Re: Comments on Final Initial Study/Mitigated Negative Declaration Green Trucking Solutions Cold Storage Project (SCH No. 2023080221; SPR 2022-002; CUP 2023-005)

On behalf of Californians Allied for a Responsible Economy ("CARE CA"), we submit these comments on the Final Initial Study / Mitigated Negative Declaration ("Final MND") prepared by the Town of Apple Valley ("Town") for the Green Trucking Solutions ("GTS") Cold Storage Project (SPR 2022-002, CUP 2023-005, SCH No. 2023080221) ("Project")¹, proposed by Green Trucking Solutions, LLC ("Applicant"). The Project proposes construction of a 354,260-square-foot cold storage warehouse building, including two 2-story office areas, an electrical and fire pump building, and 371 parking spaces for automobiles and trucks to be located on an 18.78-acre site on the northwest corner of Navajo Road and Lafayette Street, in Apple Valley California.² Project construction is expected to last approximately 16 months.³

Figure 1: 40-Mile Radius Around Project Site

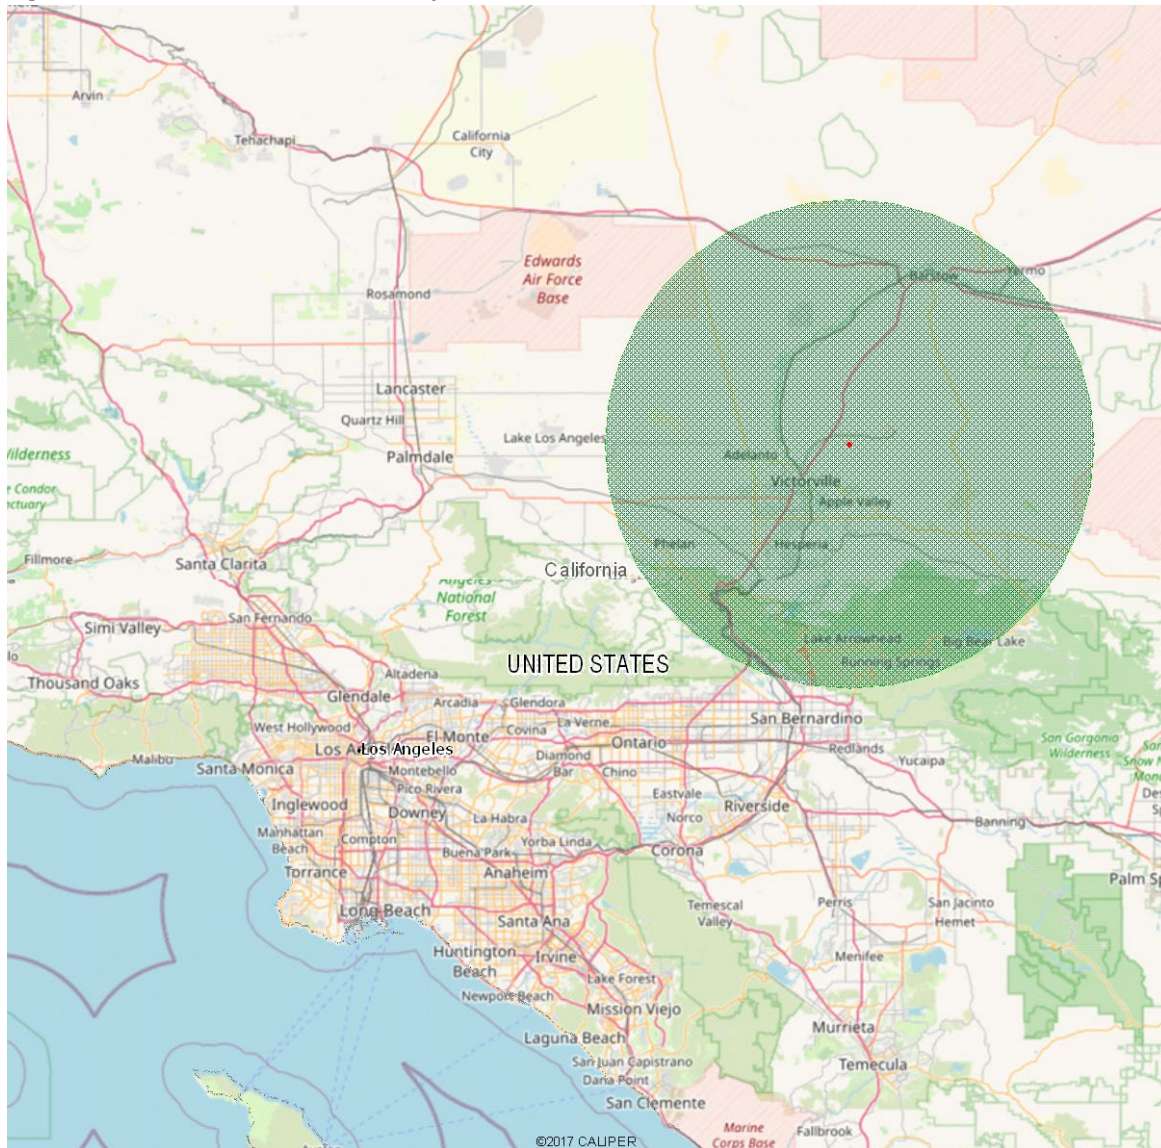
Mr. Marshall argues the 40-mile truck trip assumption is too low and recommends a 115-mile one-way trip length. (p. 109)

As shown above, I did conclude that the 40-mile length was too low but did not recommend a 115-mile trip length. The 115-mile length was suggested by another commenter based on the distance to the Ports of Long Beach and Los Angeles. I was not assuming Port trips but noted instead that there are few significant freight origins and destinations (freight transfer points, food-processing facilities, and/or population centers) within 40 miles of the proposed warehouse. I reproduce the map illustrating this again below as Figure 1.
